Your ref: MP09\_0146  
Our Ref: TP/3(8).04

Mr Alan Bright  
Acting Director, Metropolitan & Regional Projects South  
NSW Department of Planning & Infrastructure  
GPO Box 39  
SYDNEY NSW 2000

**ENVIRONMENTAL ASSESSMENT EXHIBITION – MIXED USE  
DEVELOPMENT AT EASTLAKES SHOPPING CENTRE,  
EASTLAKES (MP09\_0146)**

Figure 1 - Northern & Southern Precincts of Eastlakes Shopping Centre

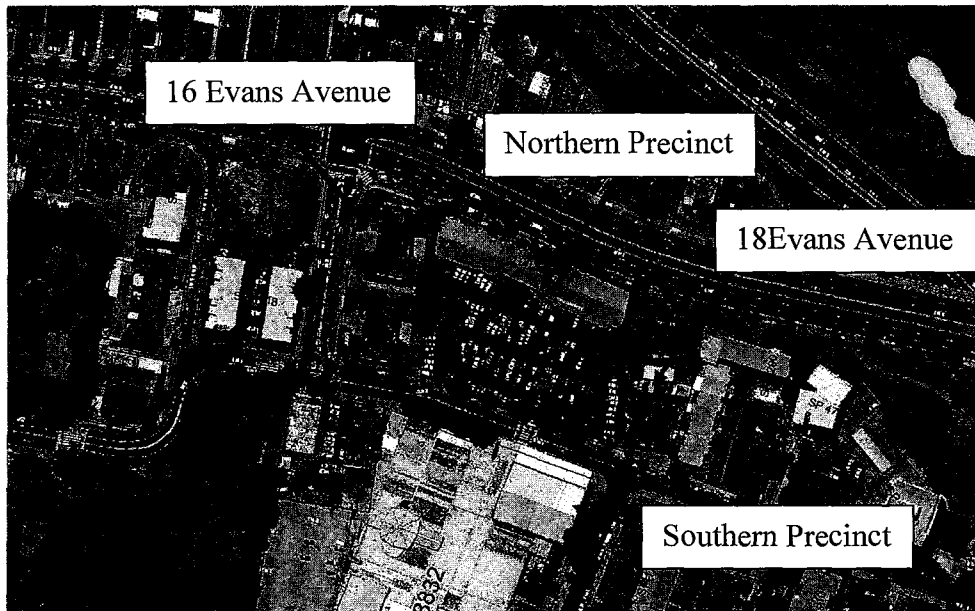
For example the proposed northern precinct is located adjacent to No. 16 and 18 Evans Avenue and No. 193 Gardeners Road.

No. 16 Evans Avenue has a primary frontage to Gardeners Road with secondary frontages to both Racecourse Parade and Evans Avenue. The proposed northern precinct is located along the eastern rear boundary of No. 16 Evans Avenue. No. 16 Evans Avenue has a site area of 2,981sqm with a site width of 36m.

Taken into consideration the location and site constraints of No. 16 Evans Avenue, Council is the opinion that the proposed northern precinct will “sterilised” and unreasonably constrain the future development opportunity of No. 16 Evans Avenue.

The proposed 6m high walls will significantly reduce the amenity and outlook for residents at No.16 and 18 Evans Avenue. It is recommended at a minimum the wall be set back from the common boundary to enable planting of landscaping and screen planting.
